OHIO TURNPIKE AND
INFRASTRUCTURE COMMISSION

ADDENDUM NO. 3

CONTRACT NO. 39-14-02

RIGHT TWO (2) LANES AND SHOULDER RECONSTRUCTION
MILEPOST 159.80 TO MILEPOST 164.82
CUYAHOGA COUNTY, OHIO

| CONTRACT 39-14-02 SHEET 176 OF 414 | | | |

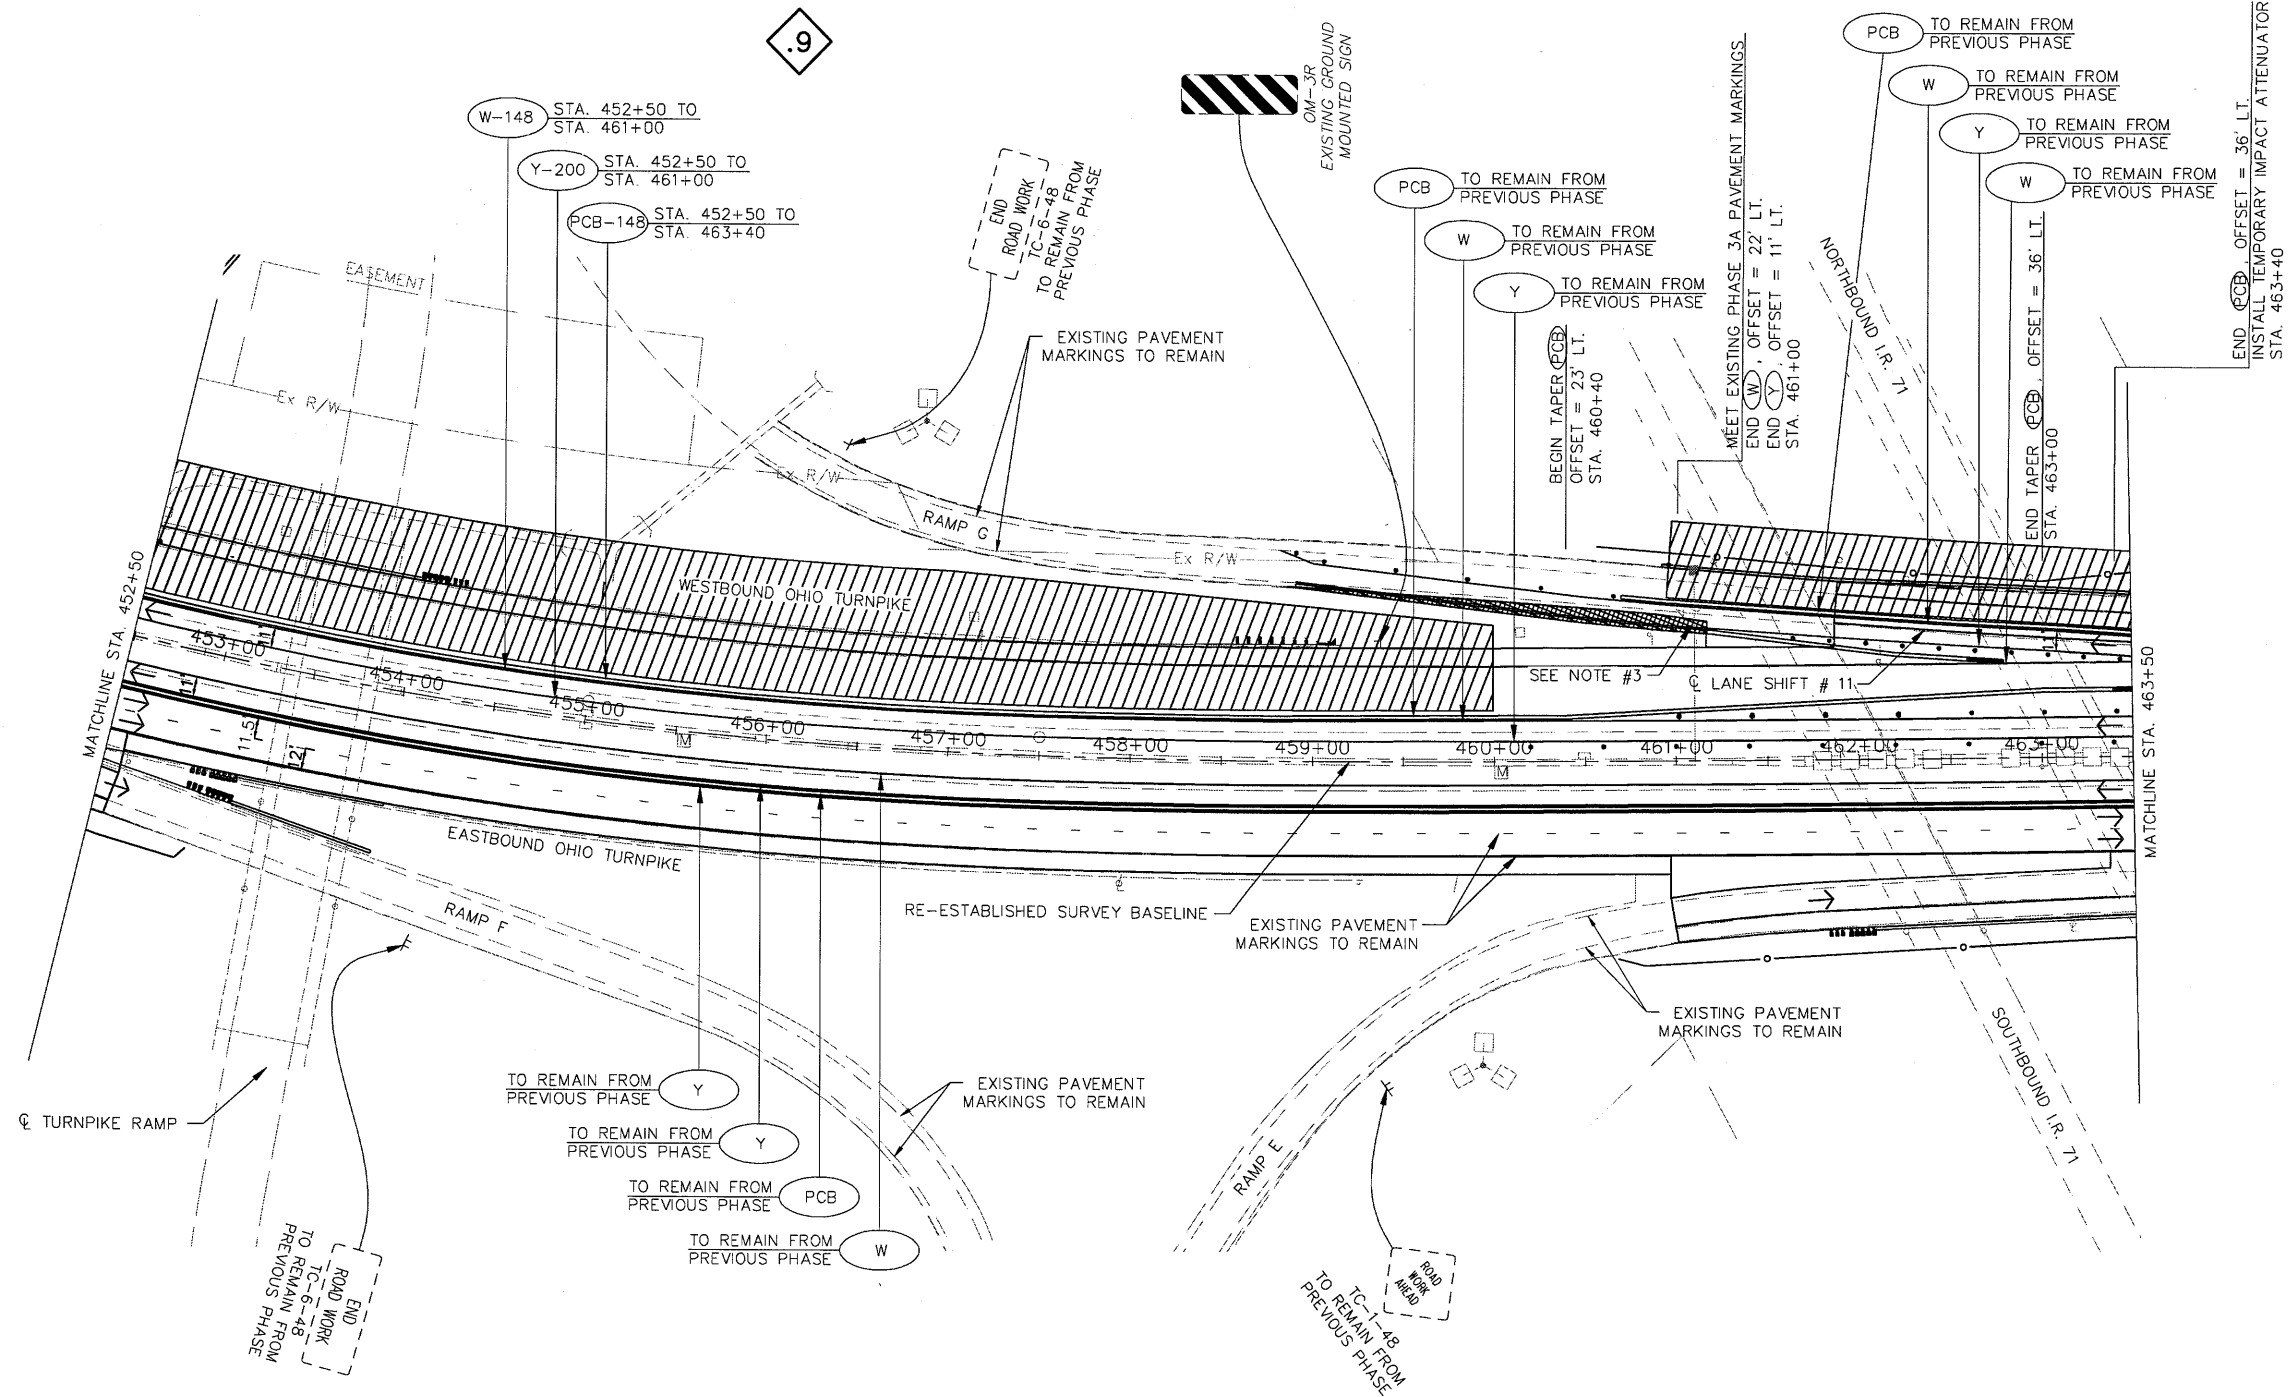
Plan Sheet 176 of 414

General Note 3 is modified via this Addendum No. 3 as follows:

- "3. TEMPORARY PAVEMENT SHALL BE PAID FOR UNDER ITEM 615 –PAVEMENT FOR MAINTAINING TRAFFIC, CLASS A. TEMPORARY EMBANKMENT SHALL BE PAID FOR UNDER ITEM 615 – ROADS **PAVEMENT** FOR MAINTAINING TRAFFIC, CLASS A, AS PER PLAN."

| CONTRACT 39-14-02 SHEET 207 OF 414 | | | |

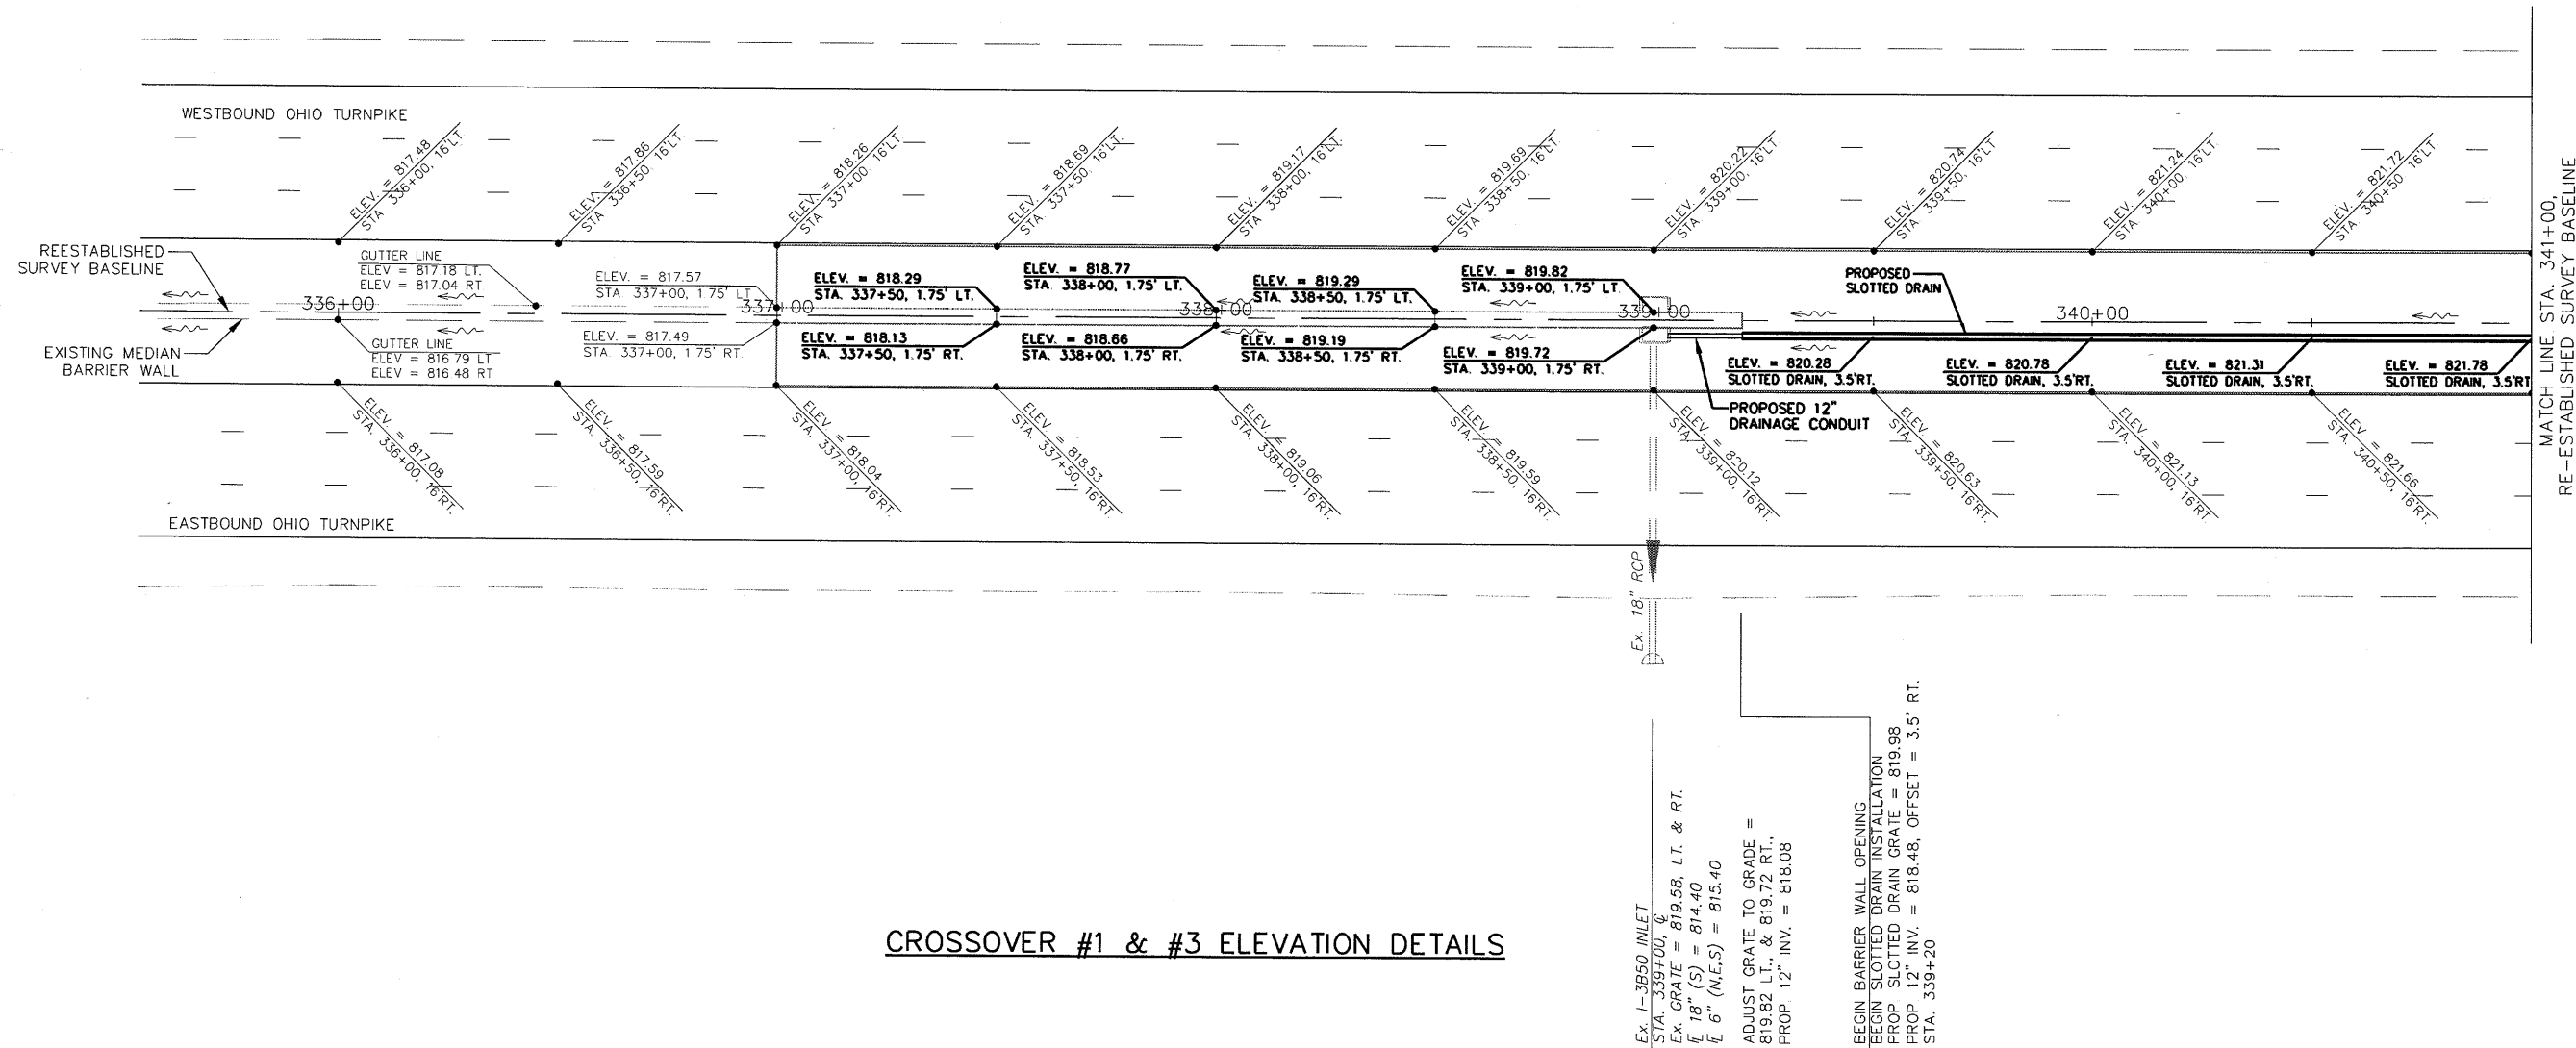
Q#23 Plan pages 207 & 210 show 12" conduit being connected from the existing catch basins to the proposed trench drain, how is this conduit paid for?

Plan Sheet 207 of 414

General Note 4 is modified via this Addendum No. 3 as follows:

A#23 The conduit necessary to temporarily connect the trench drains to the existing catch basins is considered incidental to Maintaining Traffic in the crossover areas. All costs associated with this Work shall be included in Item 615 – Pavement for Maintaining Traffic, Class A, As Per Plan.

- “3. TEMPORARY PAVEMENT SHALL BE PAID FOR UNDER ITEM 615 –PAVEMENT FOR MAINTAINING TRAFFIC, CLASS A. TEMPORARY EMBANKMENT SHALL BE PAID FOR UNDER ITEM 615 – ~~ROADS~~ **PAVEMENT** FOR MAINTAINING TRAFFIC, CLASS A, AS PER PLAN.”

| CONTRACT 39-14-02 SHEET 208 OF 414 | | | |

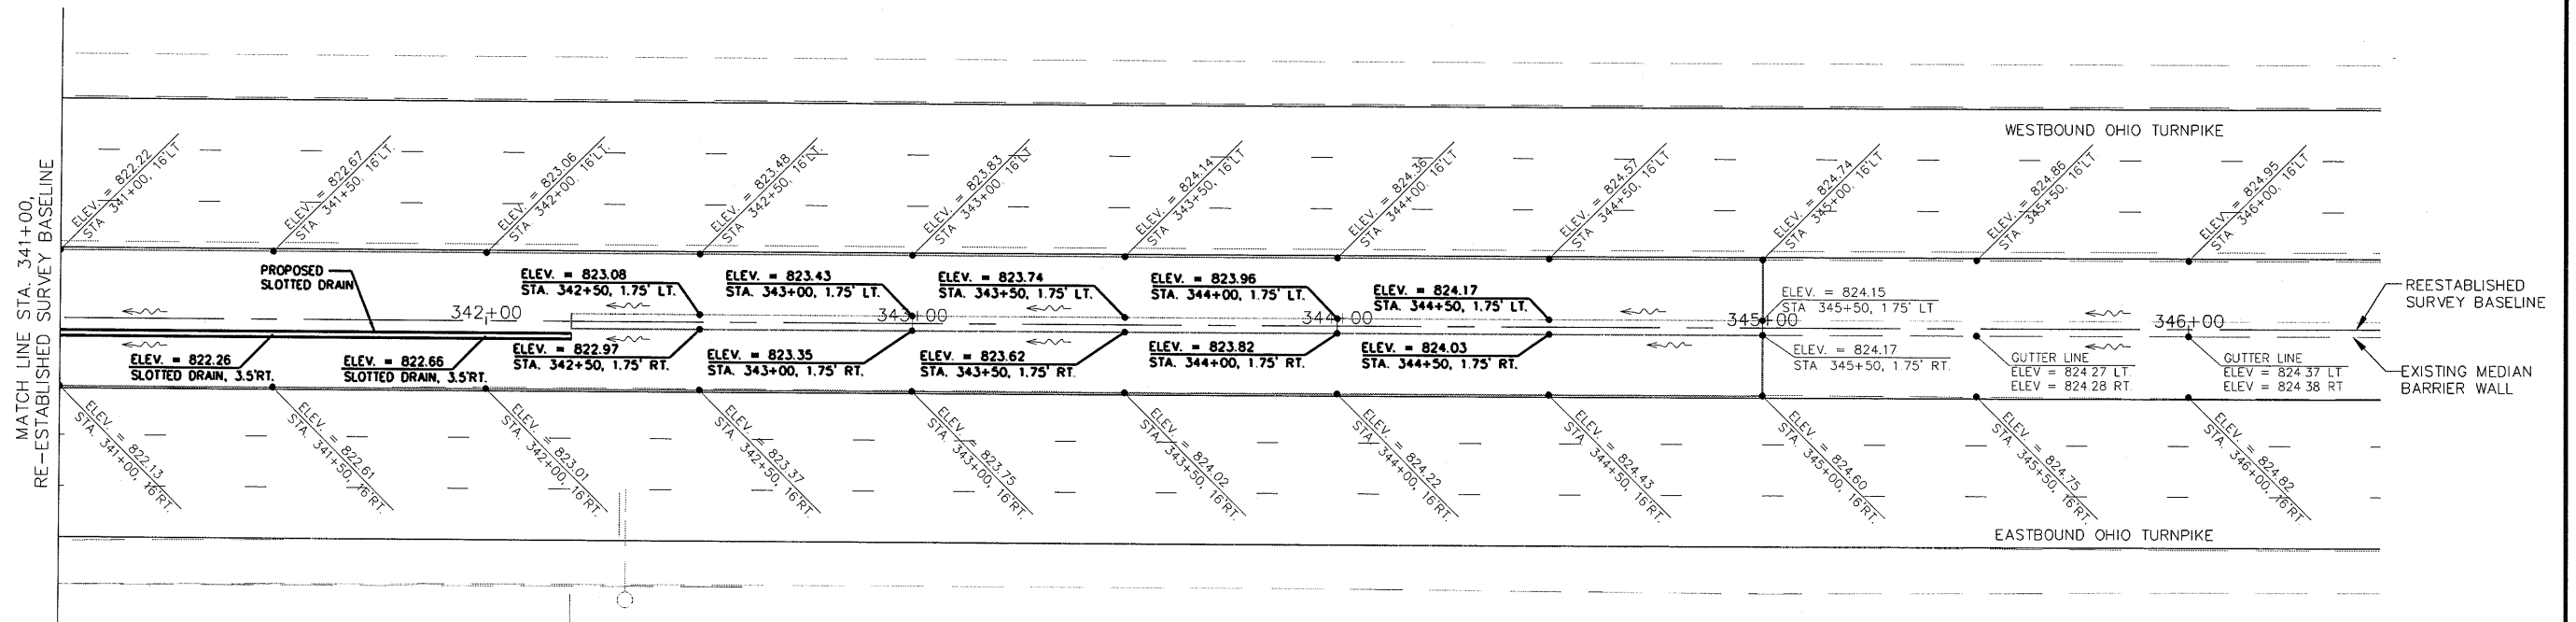
Plan Sheet 208 of 414

General Note 4 is modified via this Addendum No. 3 as follows:

- “3. TEMPORARY PAVEMENT SHALL BE PAID FOR UNDER ITEM 615 –PAVEMENT FOR MAINTAINING TRAFFIC, CLASS A. TEMPORARY EMBANKMENT SHALL BE PAID FOR UNDER ITEM 615 – ~~ROADS~~ **PAVEMENT** FOR MAINTAINING TRAFFIC, CLASS A, AS PER PLAN.”

| CONTRACT 39-14-02 SHEET 209 OF 414 | | | |

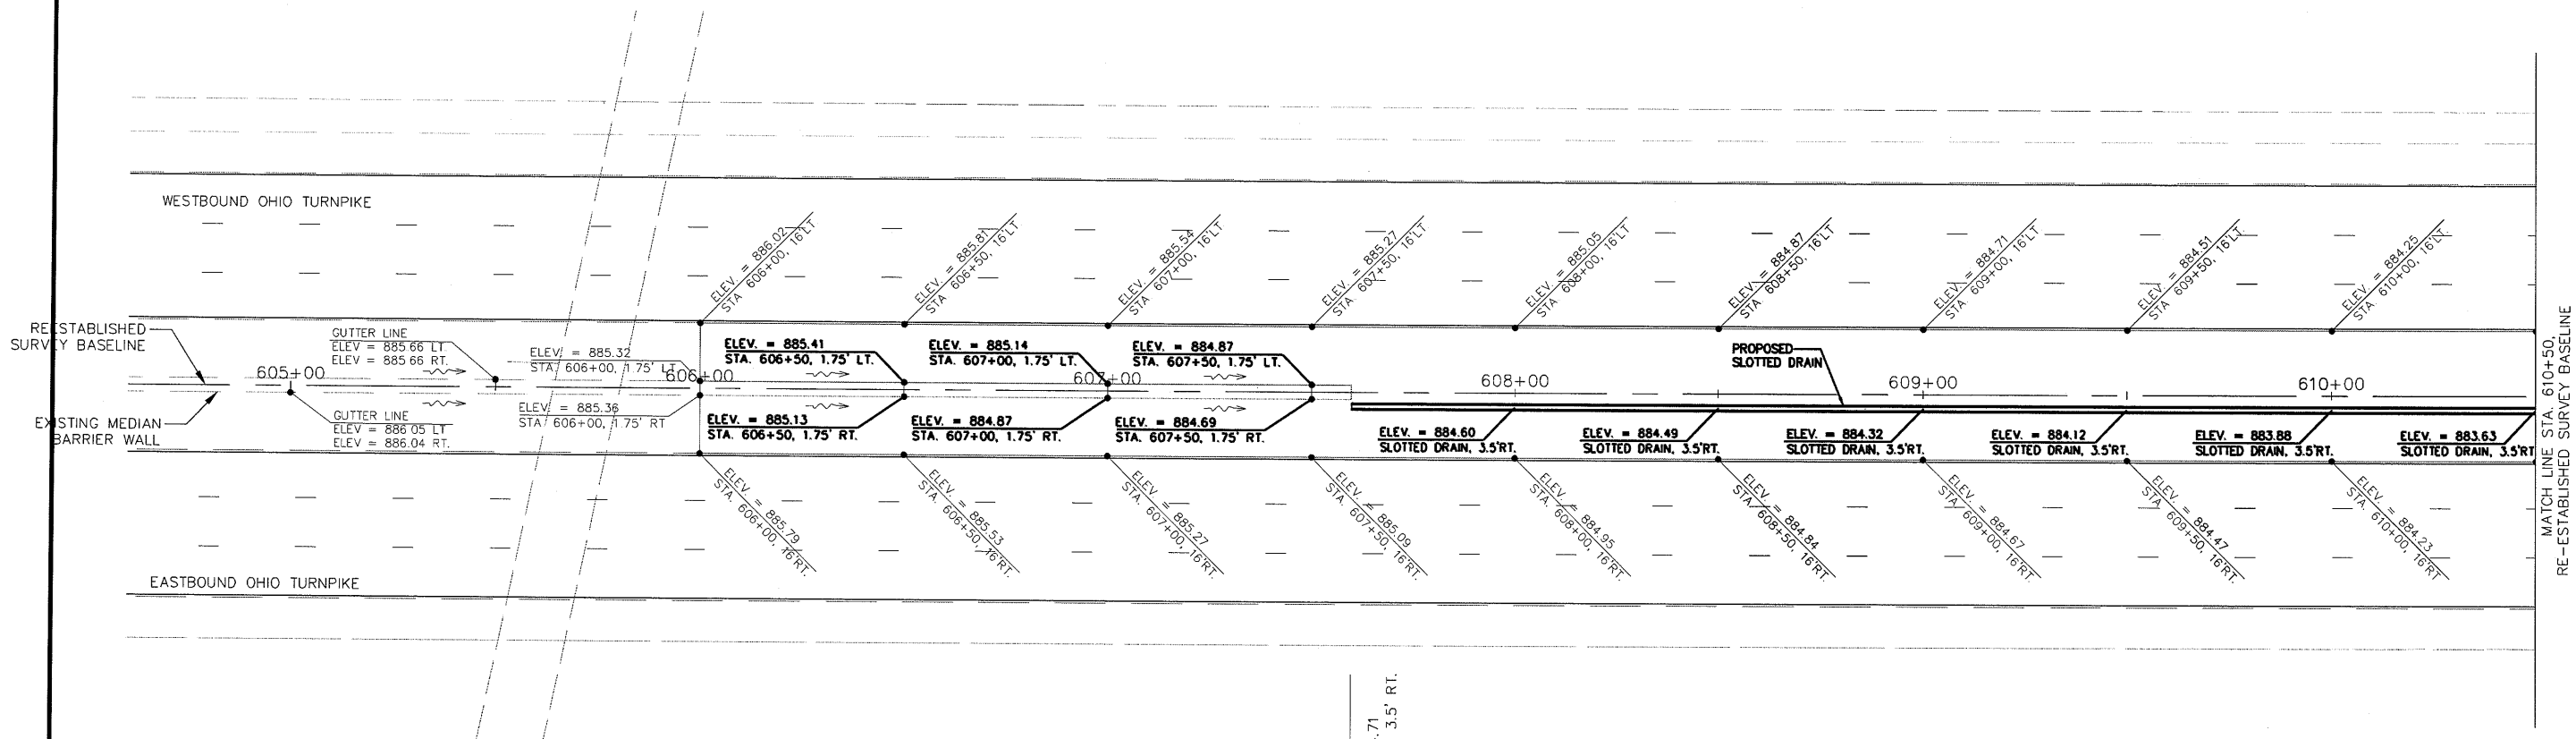
Plan Sheet 209 of 414

General Note 4 is modified via this Addendum No. 3 as follows:

- “3. TEMPORARY PAVEMENT SHALL BE PAID FOR UNDER ITEM 615 –PAVEMENT FOR MAINTAINING TRAFFIC, CLASS A. TEMPORARY EMBANKMENT SHALL BE PAID FOR UNDER ITEM 615 – ~~ROADS~~ **PAVEMENT** FOR MAINTAINING TRAFFIC, CLASS A, AS PER PLAN.”
